SERVICE TECHNICAL INFORMATION

REF. NO.: S1-97-025

MODEL : HS-JX819/-JX839/-JX859/-JX959

SUBJECT : Large noise during FM stereo reception

TUNER C. B

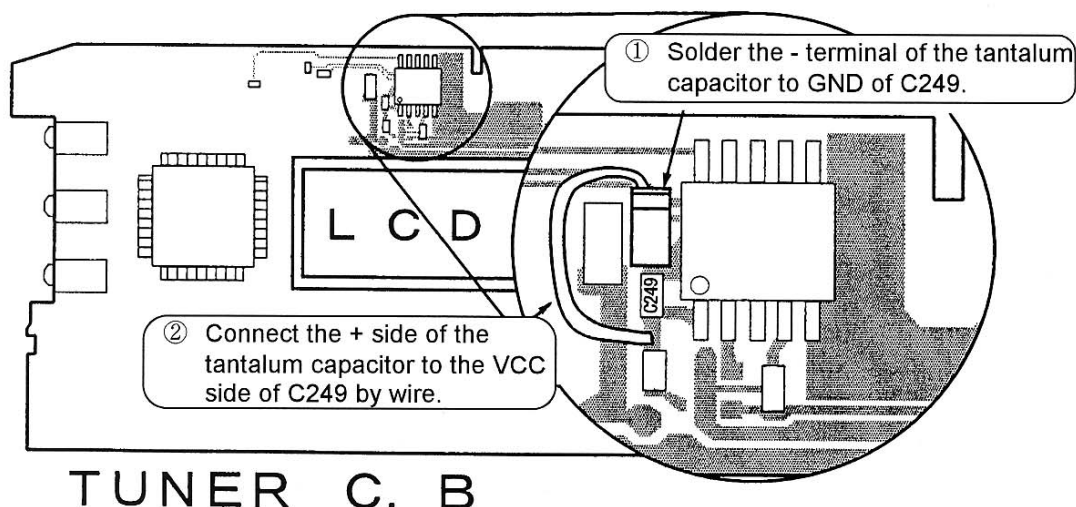
CONTENTS : In the above headphone stereos, "hoot" noise (oscillation sound at 500 Hz) may be heard from the headphones during FM stereo reception. In such a case, perform the remedy below.

REMEDY : Connect a tantalum capacitor of 10 μ F in parallel to the ceramic capacitor of 0.01 μ F which is connected to the power supply of the prescaler IC.

For the products of serial No. *****77A0001 and later, measures are taken by changing the resistor R246 of the power supply of the prescaler IC from 33 to 10 Ω in the production process.
